**HORIZONTAL DIRECTIONAL DRILL ANALYSIS
NORTH POTTSTOWN PIKE CROSSING
PADEP SECTION 105 PERMIT NO.: E15-862
PA-CH-0212.0000-RD
(SPLP HDD No. S3-0370)**

**NORTH POTTSTOWN PIKE CROSSING
PADEP SECTION 105 PERMIT NO.: E15-862
PA-CH-0212.0000-RD
(SPLP HDD No. S3-0370)**

Proposed Modification to Construction Methods Resulting from Additional Investigation

Re: **Sunoco Pipeline L.P. – Pennsylvania Pipeline Project (Mariner East II)**
Chapter 102 Permit No. ESG 01 000 15 001 Modification Request Two
Request for additional LOD associated with revised pipeline installation technique
North Pottstown Pike-HDD S3-0370
West Whiteland Township, Chester County, PA

1-20" & 1-16" WELDED STEEL NATURAL GAS PIPELINES
CHESTER COUNTY CONSERVATION DISTRICT
EROSION & SEDIMENT CONTROL &
SITE RESTORATION PLAN
SHEET 45 OF 74

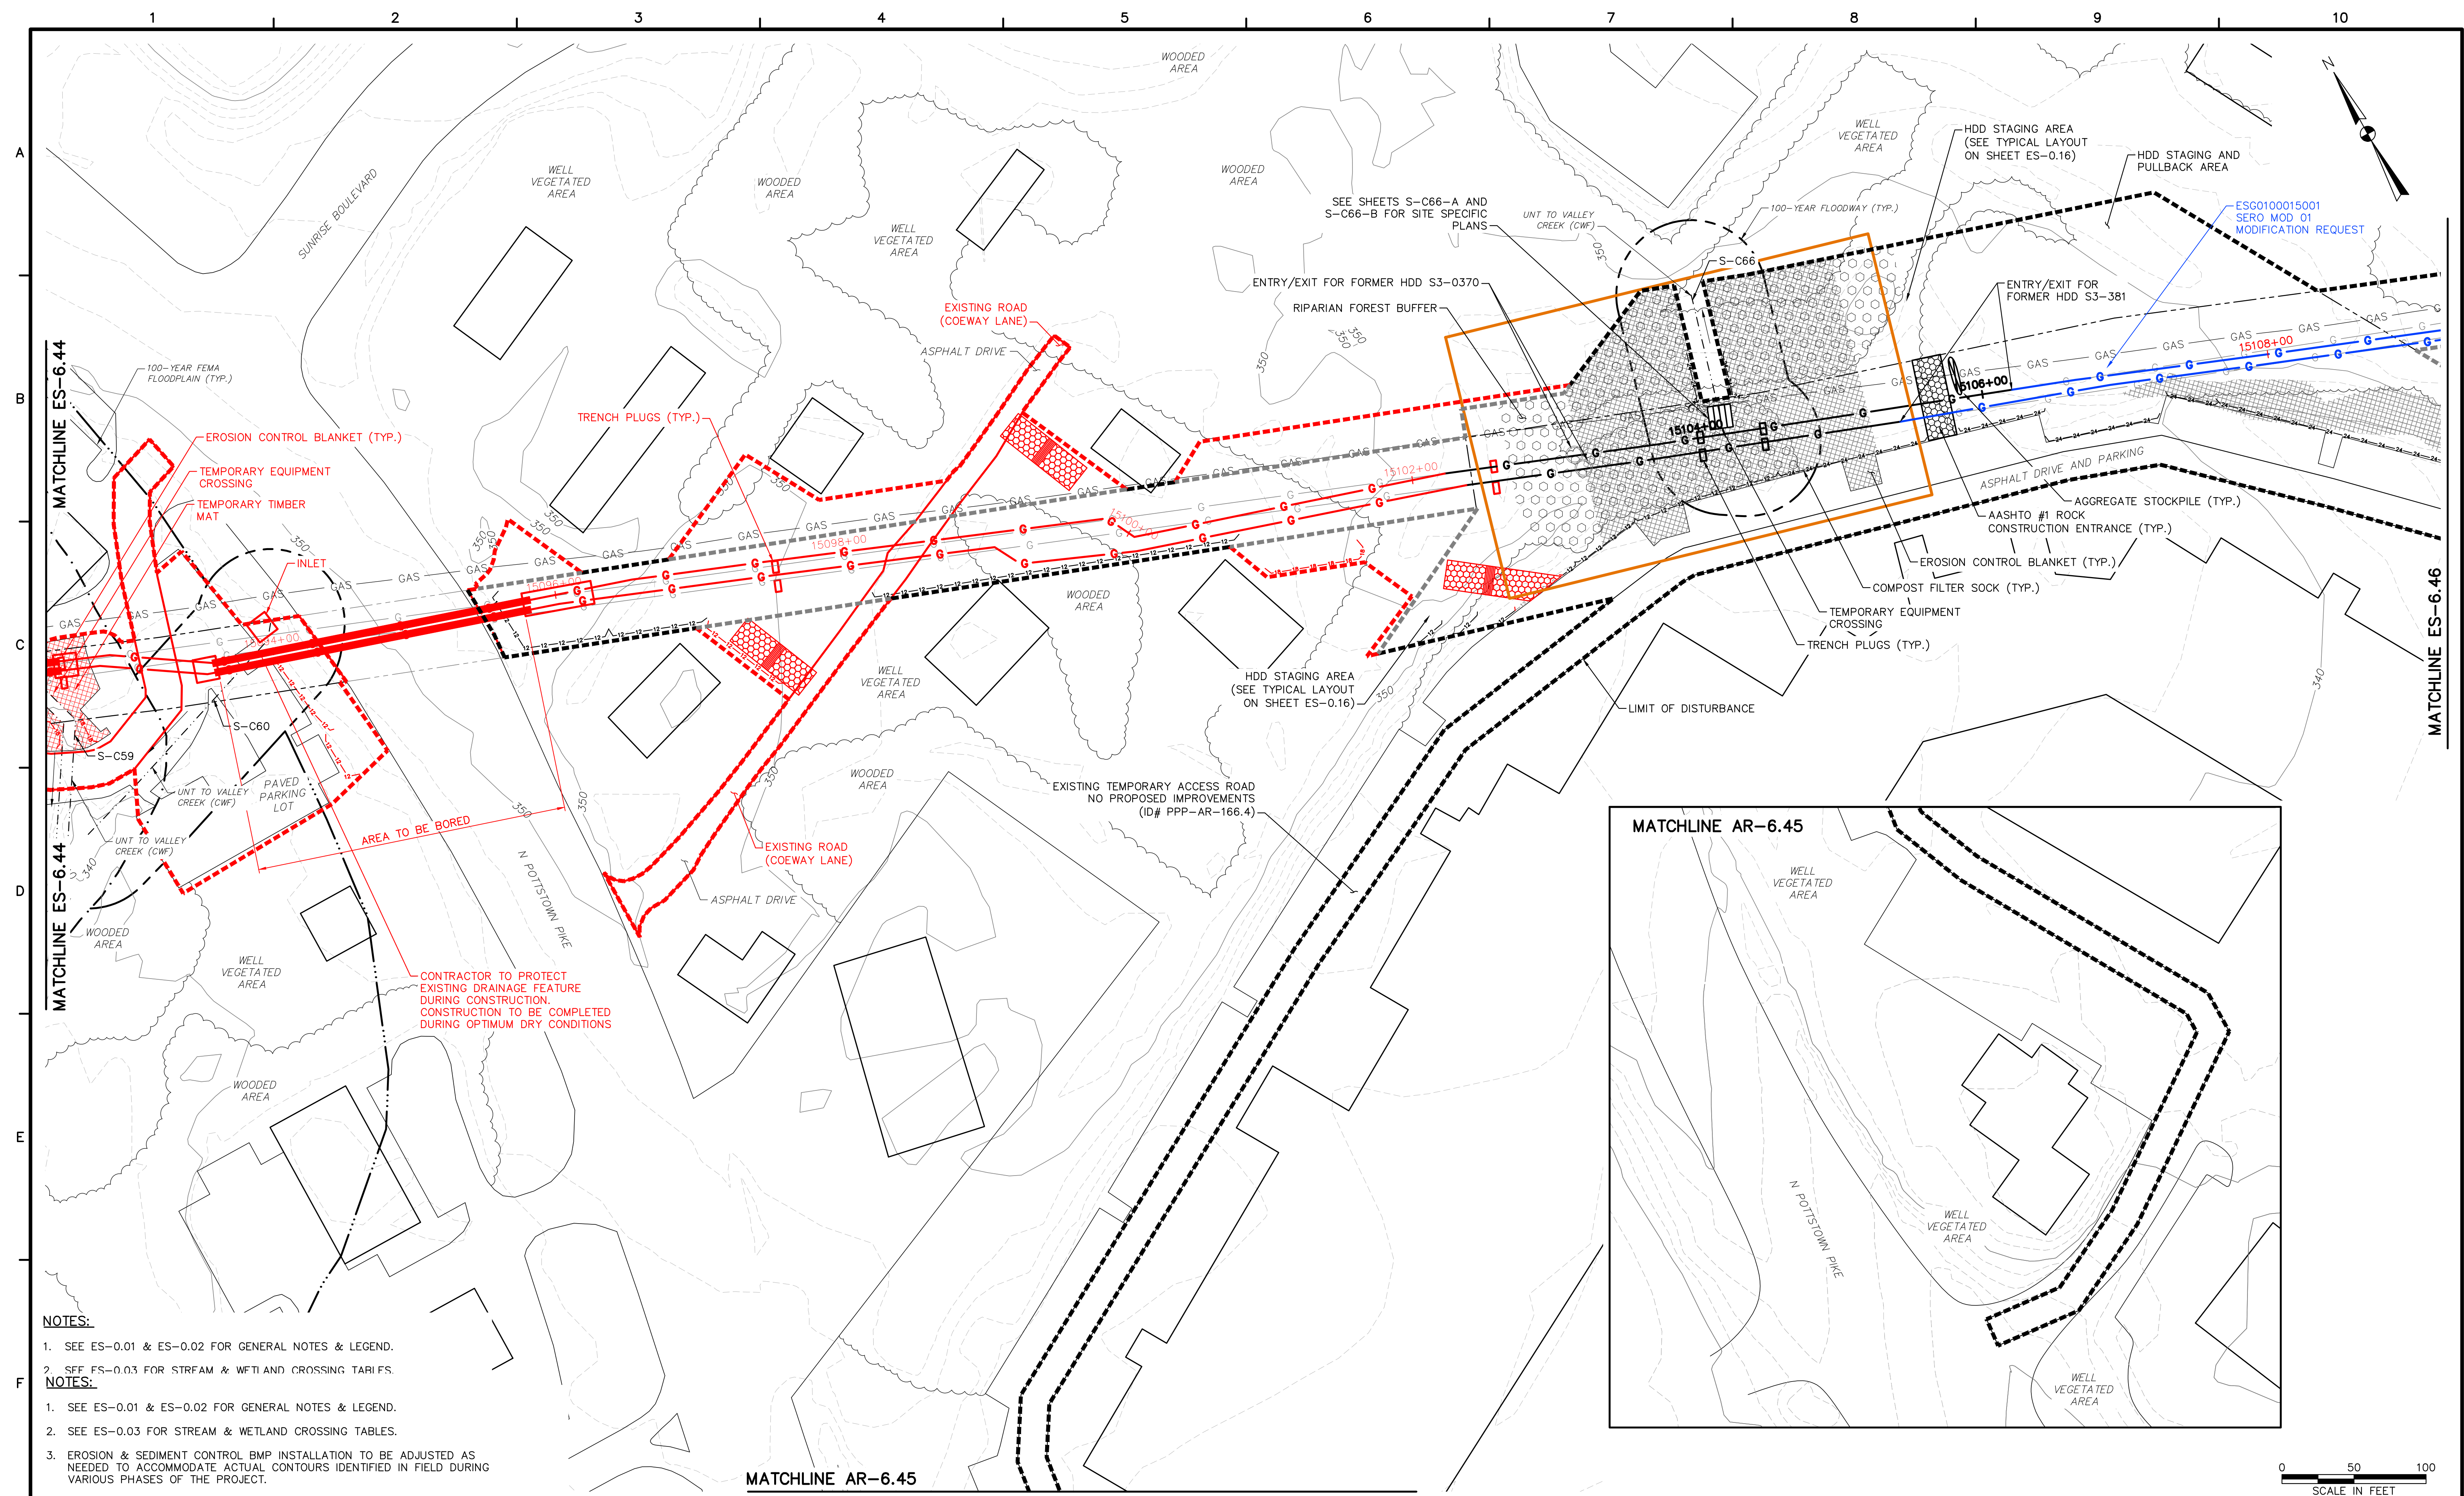
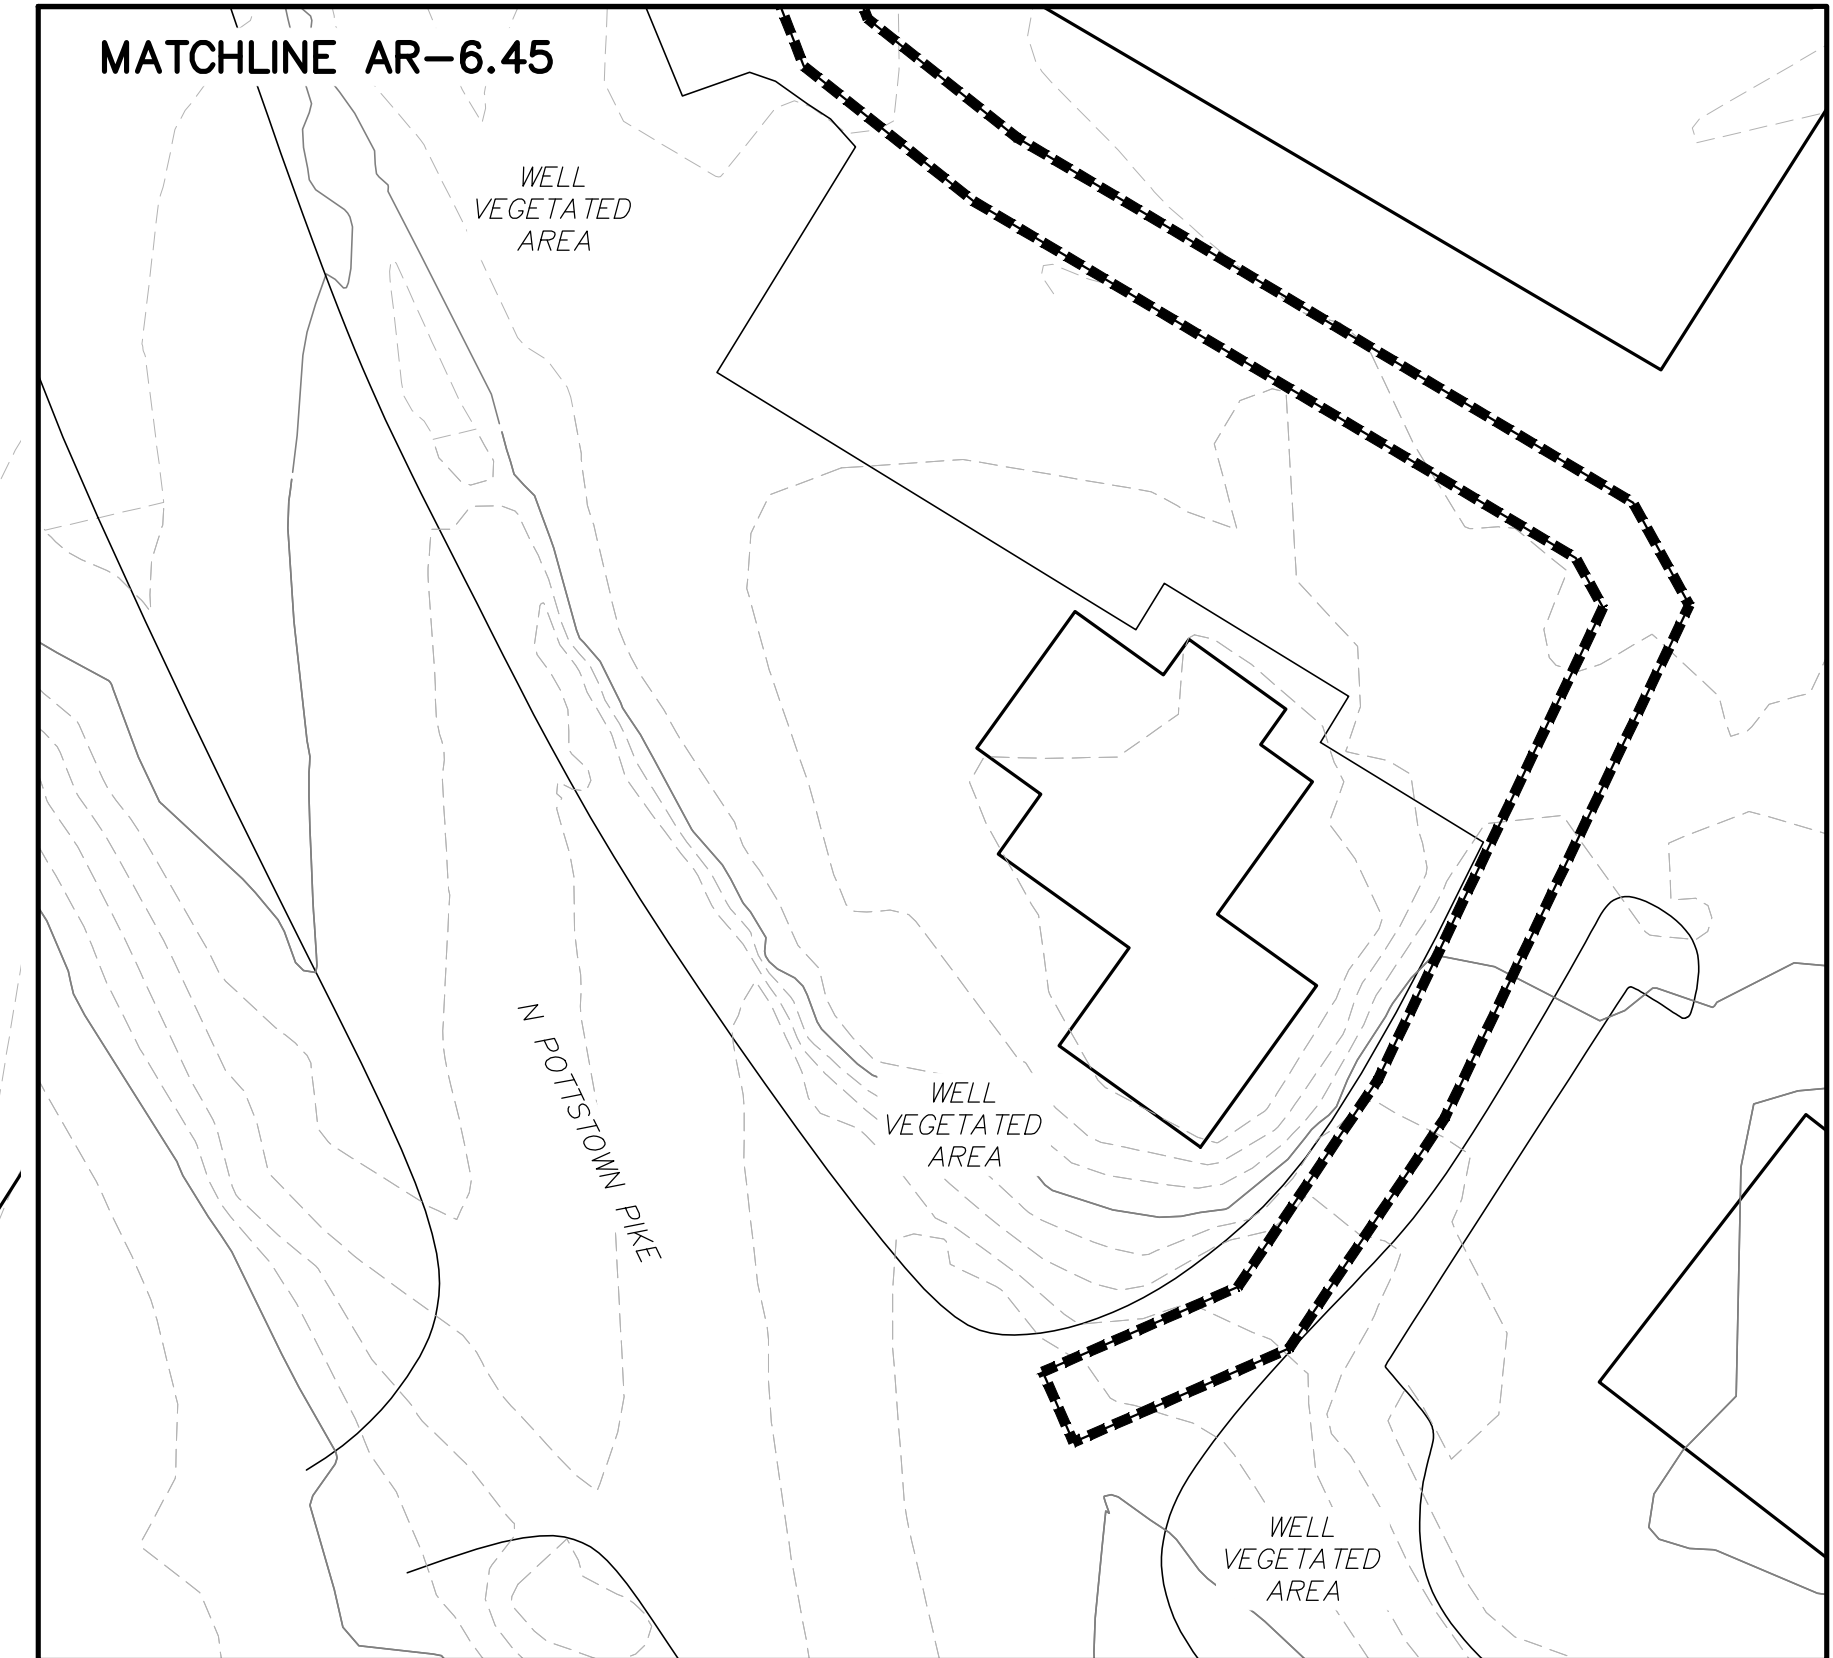
NO.		BY	DATE	REVISIONS	REMARKS
1	RS		3/28/17	INCORPORATED THE SPECIAL CONDITIONS SET FORTH IN DEP'S CHAPTER 102 AND CHAPTER 105 PERMITS	
2	RS		5/25/17	REDLINE REVISIONS	
3	RS		5/26/17	HDD TO OPEN CUT-MAJOR MODIFICATION I-STA 15106+00 TO STA 15159+00	
4	RS		8/18/17	HDD TO OPEN CUT-MAJOR MODIFICATION II-STA 15084+00 TO STA 15102+00
